Subject: Transmittal of Revision 1 to Service Bulletin Number
V2500-ENG-72-0132

International Aero Engines SERVICE BULLETIN

ENGINE - LP COMPRESSOR - REMOVAL OF
STAGE 6 BUFFER AIR SYSTEM

V2500 - ENG - 72 - 0132

Location of the Seal Support Assembly,
Air Feed Tube Assemblies and Related Parts
Figure 6 (Sheet 1 of 6)

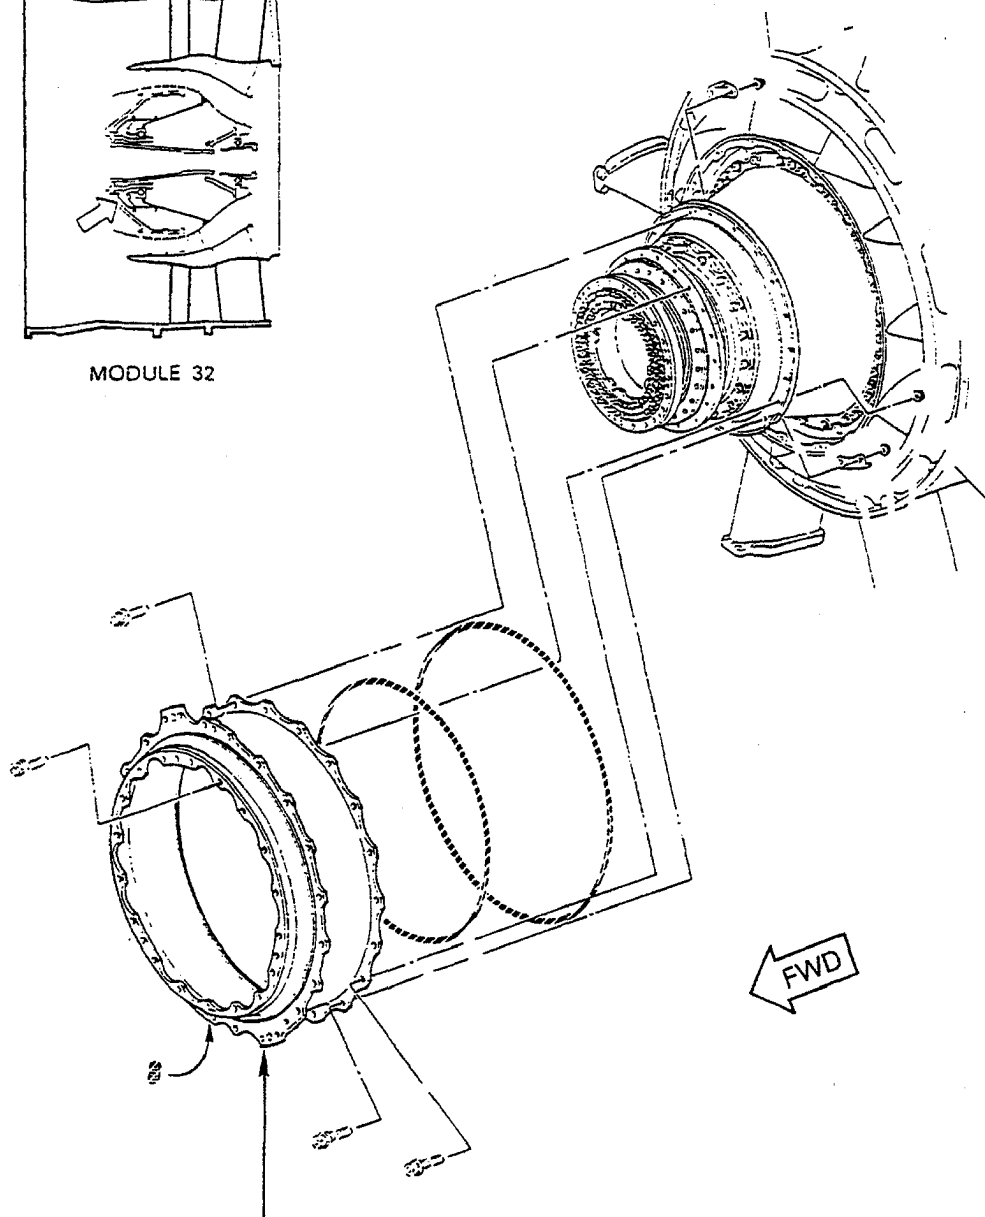
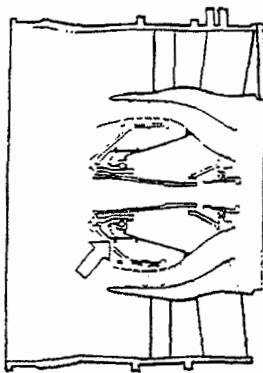
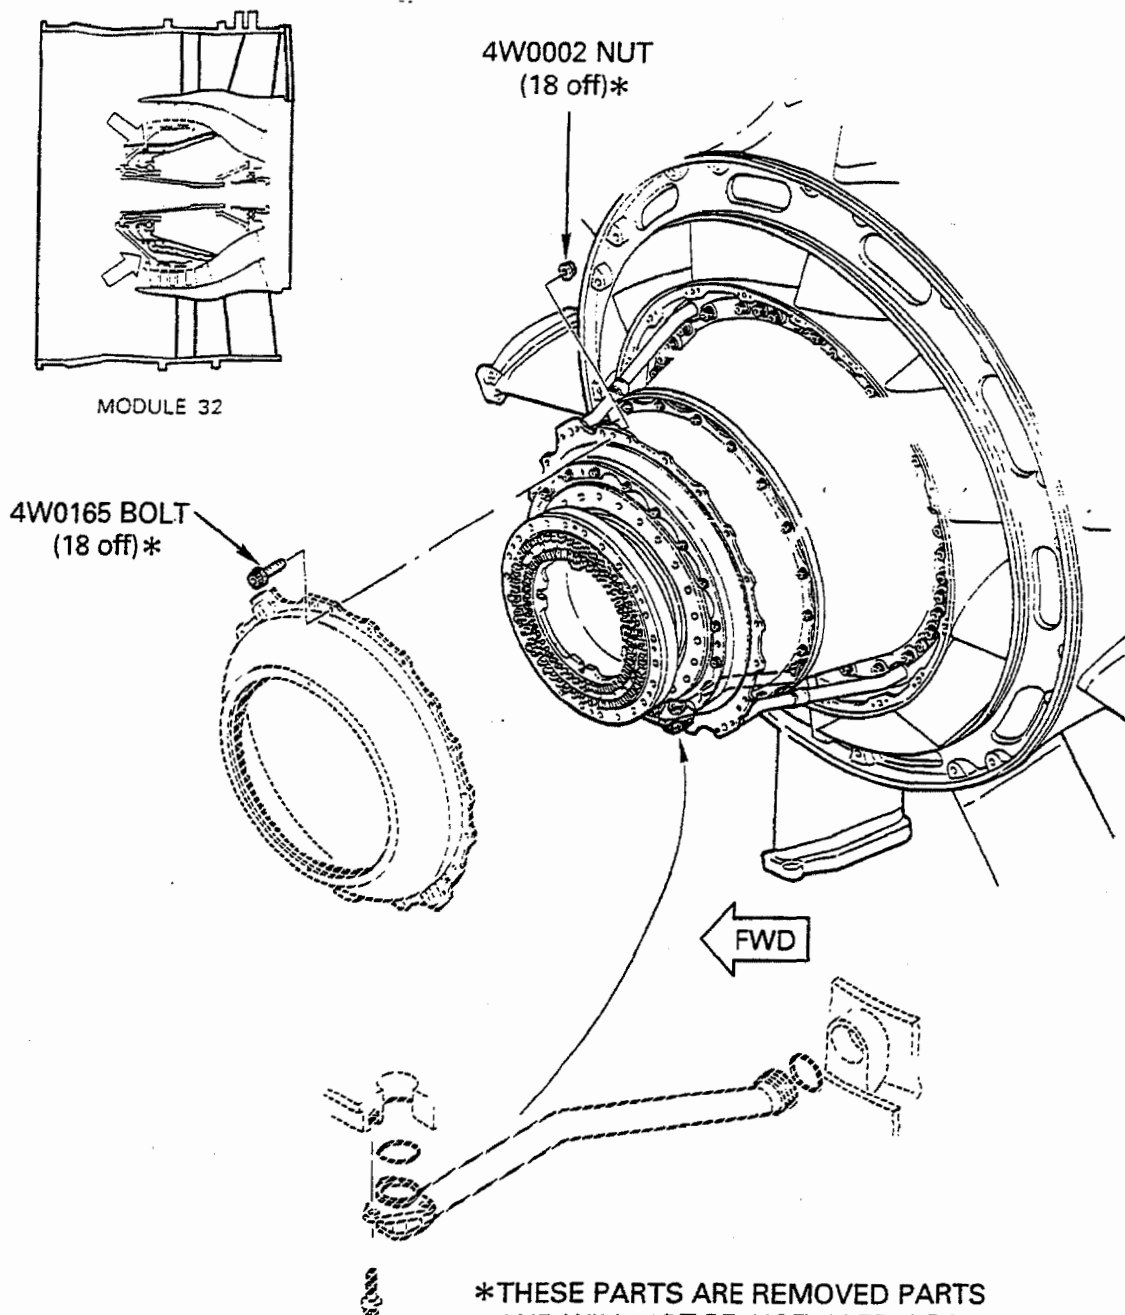
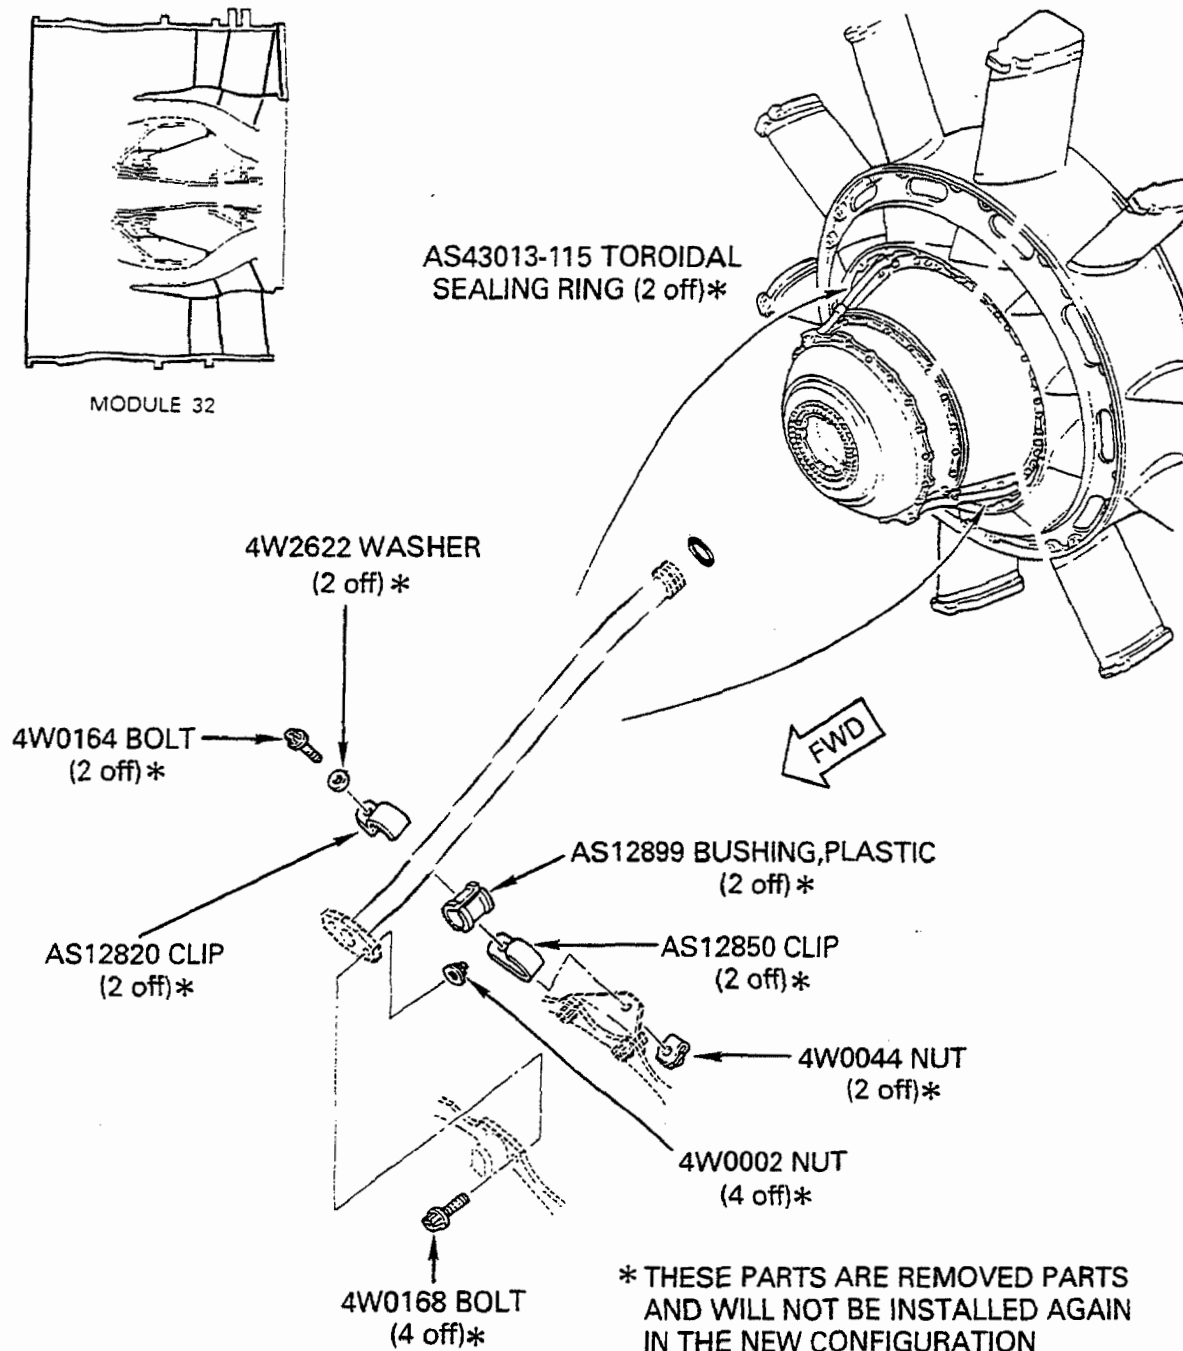
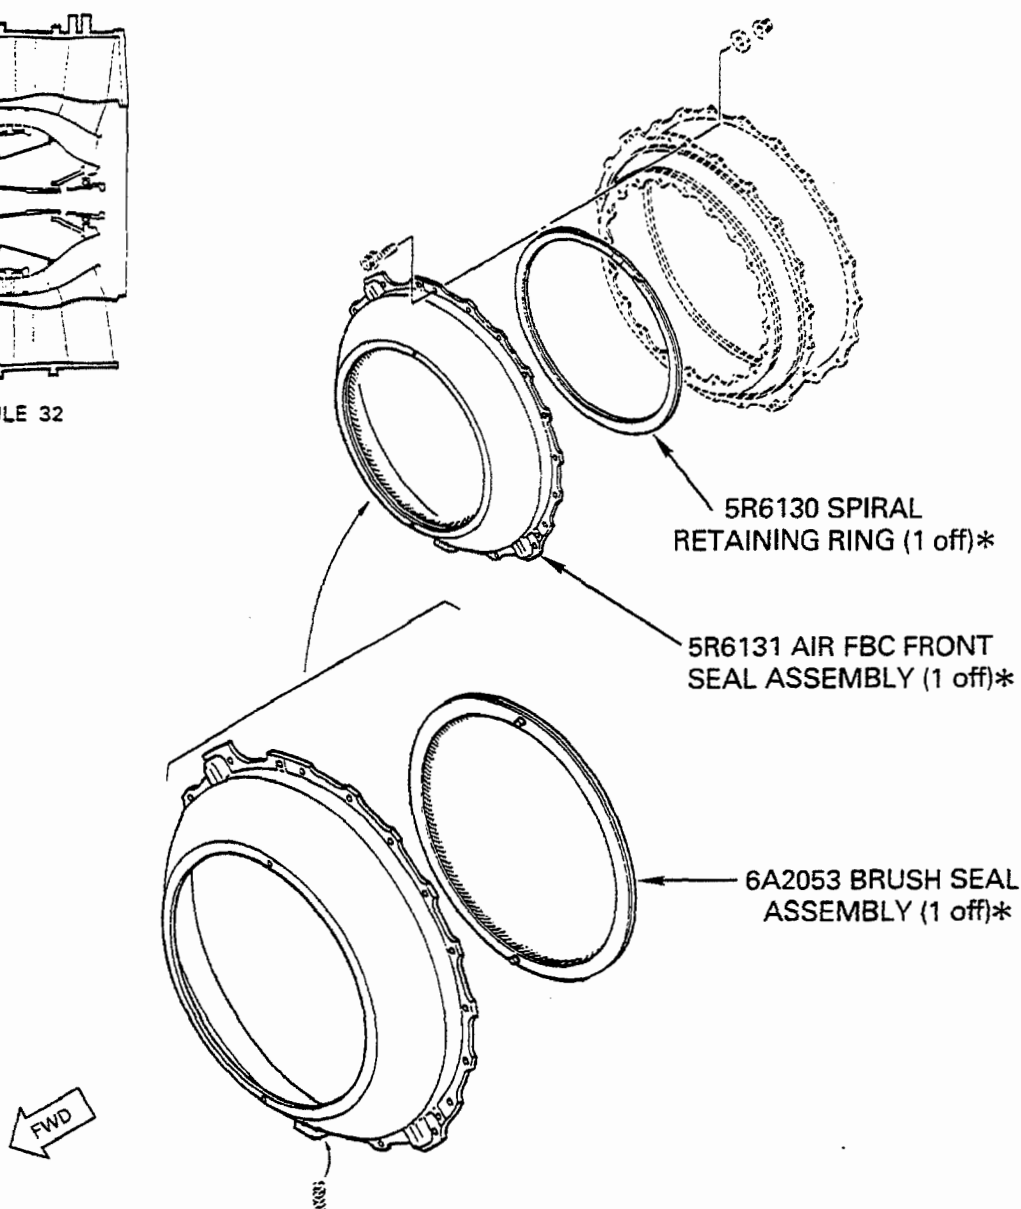
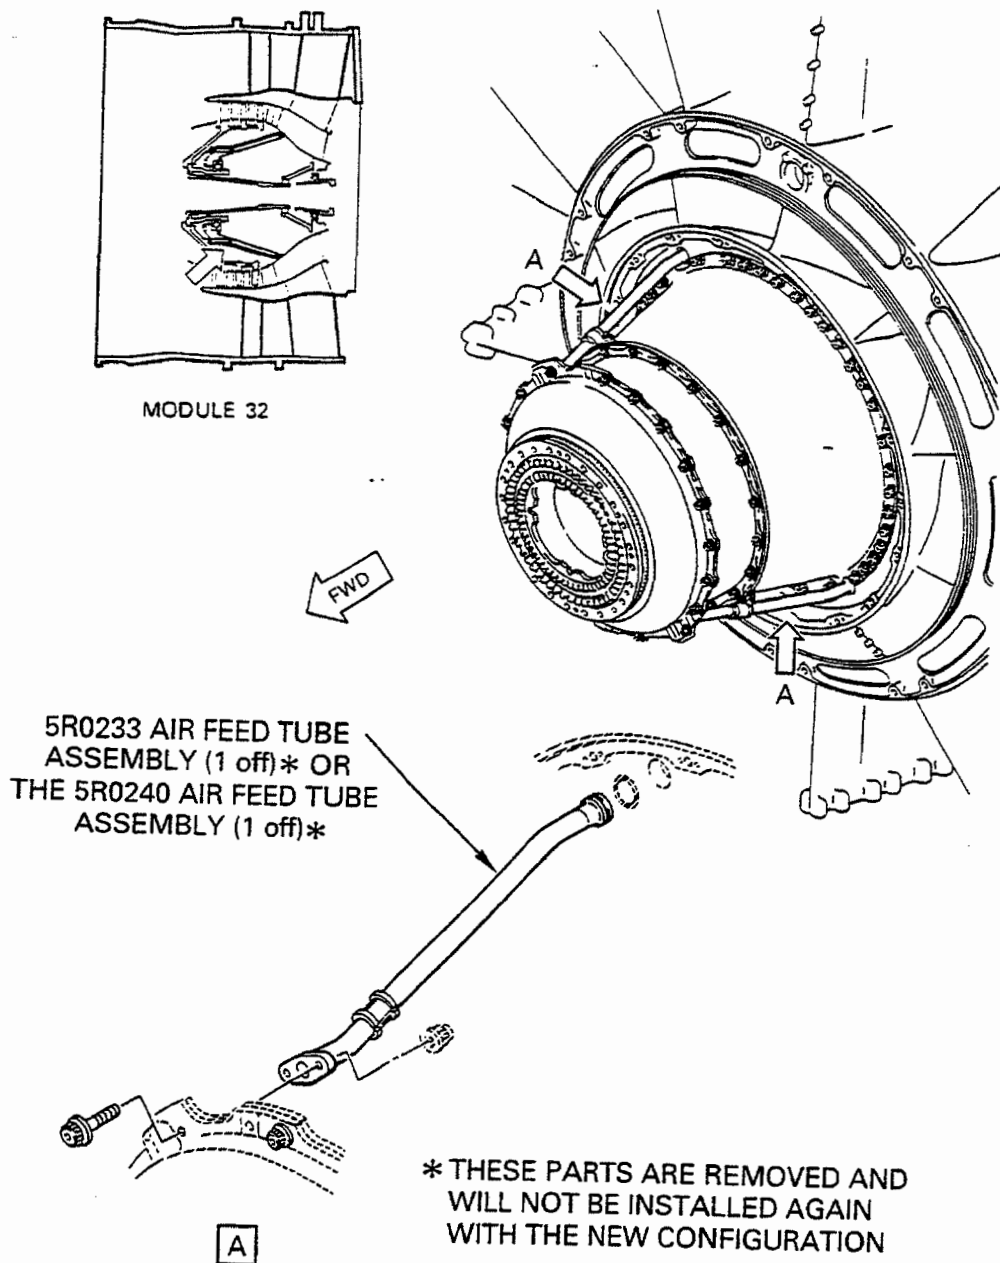
- (a) Install the 5W2078 Seal Support Assembly (1 off). See Figure 6.
- (b) Install the MS9321-10 Washers (21 off) when you install the 4W0002 Nuts (21 off) and the 4W0168 Bolts (21 off) that hold the Seal Support. See Figure 6.
- (c) Install the MS9321-10 Washers (18 off) and safety the Seal Support Assembly with the AS21013 Bolts (18 off). See Figure 6.
- (d) When you do the procedure the parts listed below will not be installed:

- 1 the 5R0245 Brackets (2 off), one each at two locations
- 2 the 4W0164 Bolts (2 off), one each at two locations
- 3 the 4W0165 Bolts (18 off),
- 4 the 4W0002 Nuts (18 off),
- 5 the 4W2622 Washers (2 off), one each at two locations
- 6 the 4W0044 Nuts (2 off), one each at two locations
- 7 the AS12820 Clips (2 off), one each at two locations
- 8 the AS12850 Clips (2 off), one each at two locations
- 9 the AS12899 Bushing (2 off), one each at two locations
- 10 the 4W0002 Nuts (4 off),
- 11 the 4W0168 Bolts (4 off),

- 12 the AS43013-115 Sealing Rings (2 off), one each at two locations
- 13 the 5R6130 Spiral Retaining Ring (1 off),
- 14 the 5R6131 FBC Front Air Seal Assembly (1 off),

- 15 the 6A2053 Brush Seal Assembly (1 off),
- 16 and the 5R0233 Air Feed Tube Assembly (1 off) or the 5R0240 Air Feed Tube Assembly (1 off). See Figure 6.

Location of the Air FBC Rear Seal Assembly
Figure 7

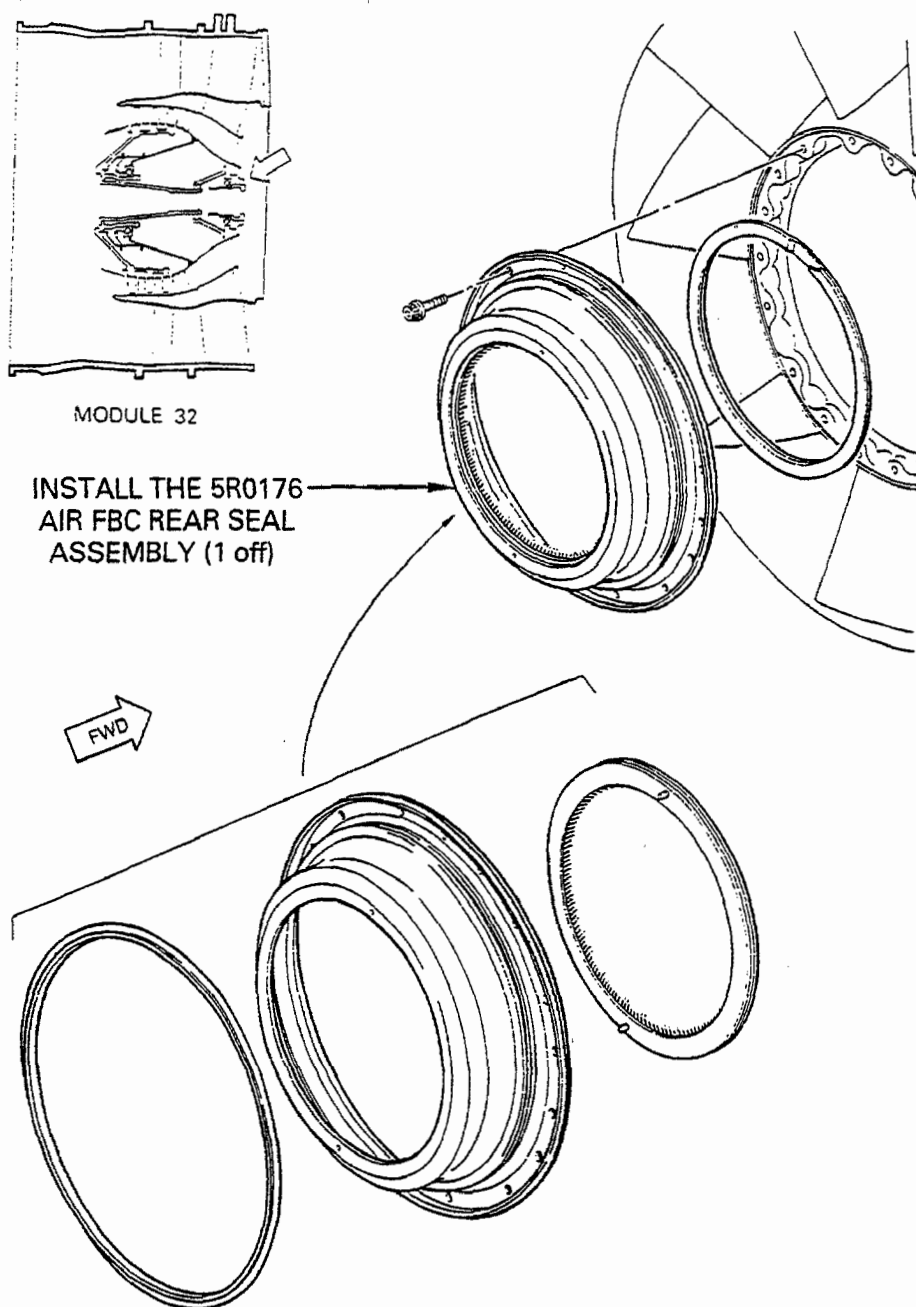
- (5) When you do the procedure given in Reference (3), Chapter/Section 72-32-00, Assembly-11, install the 5R0176 Air FBC Rear Seal Assembly (1 off). See Figure 7.

Location of the Bracket (6A2167)
Figure 8

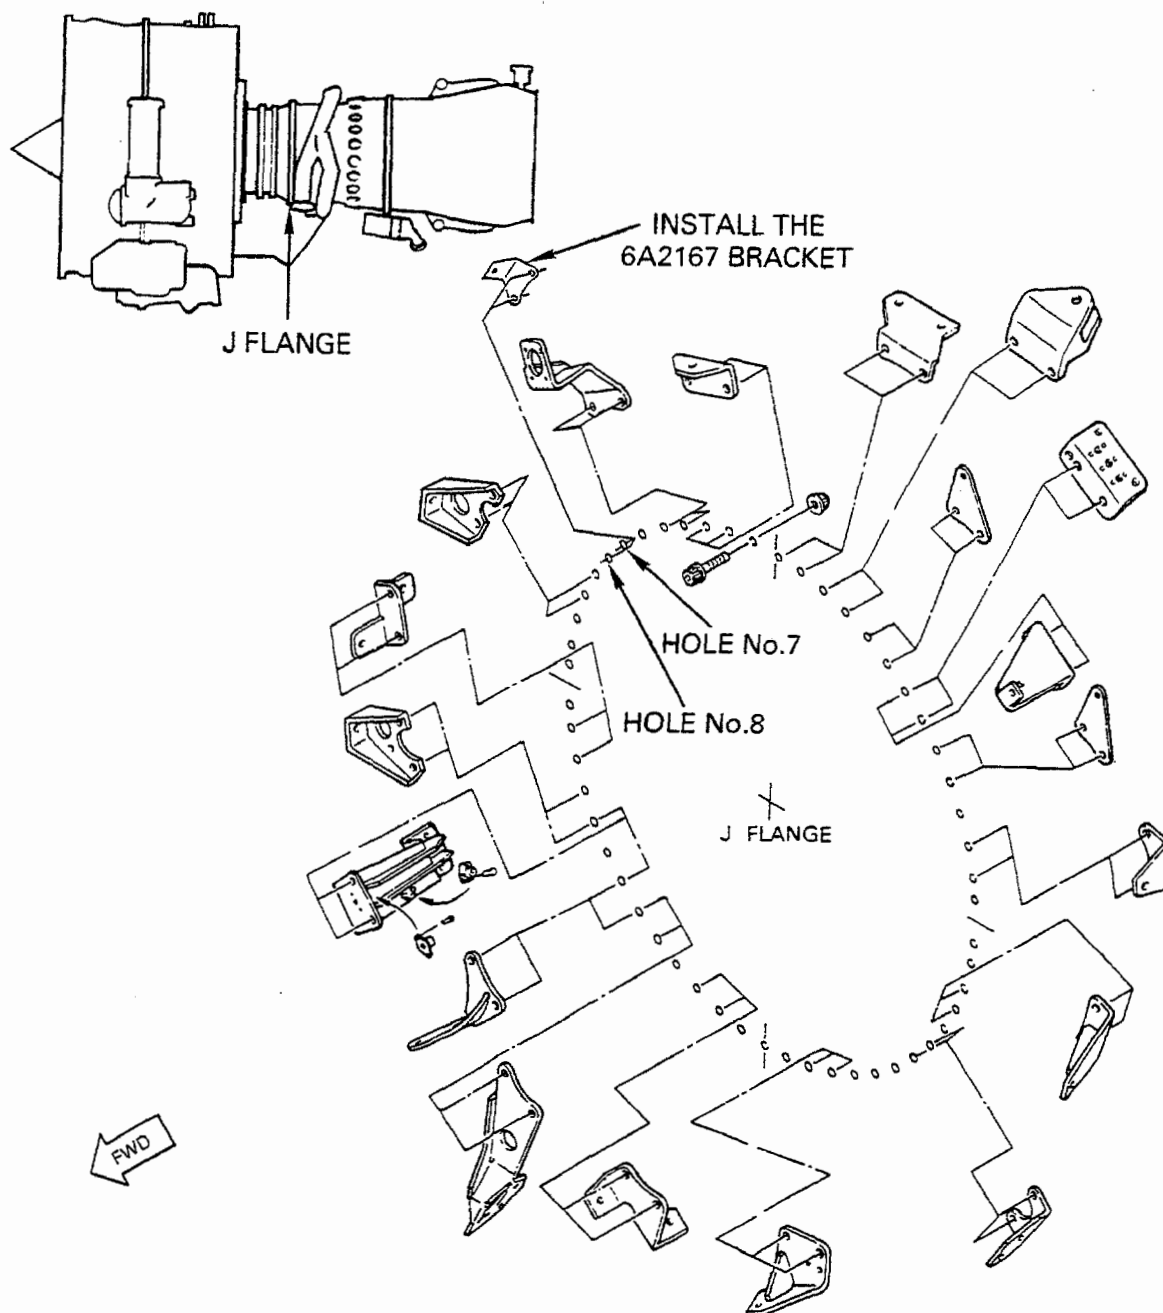
- (6) When you do the procedure given in Reference (3), Chapter/Section 72-41-00, Assembly-02, install the 6A2167 Bracket, on bolt holes 7 and 8. See Figure 8.

Location of the Brackets (5W8365 and 5W8394)
Figure 9

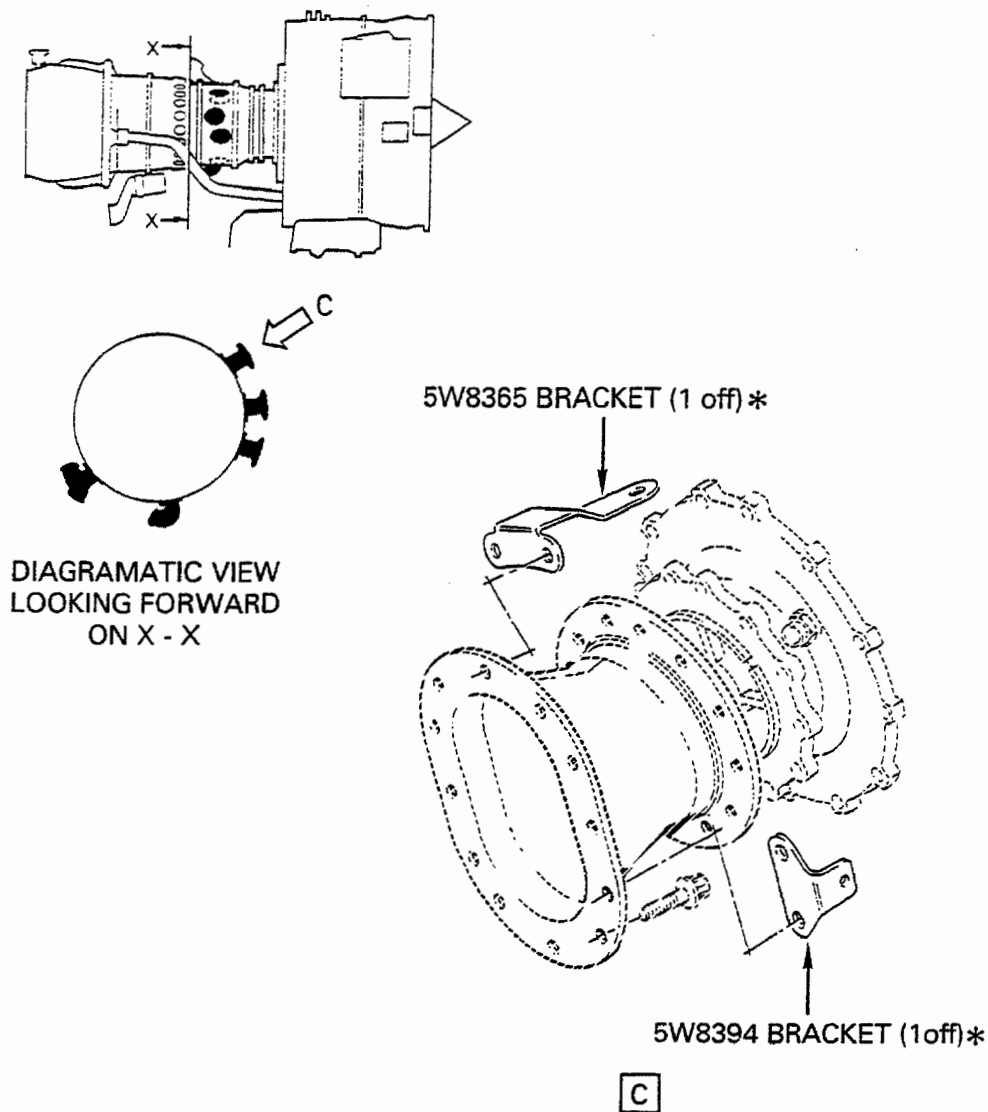
- (7) When you install the Stage 7 HP Compressor Bleed Valve by the procedure given in Reference (3), Chapter/Section 72-00-40, Installation-08, do not install the 5W8365 Bracket (1 off) and the 5W8394 Bracket (1 off). See Figure 9.
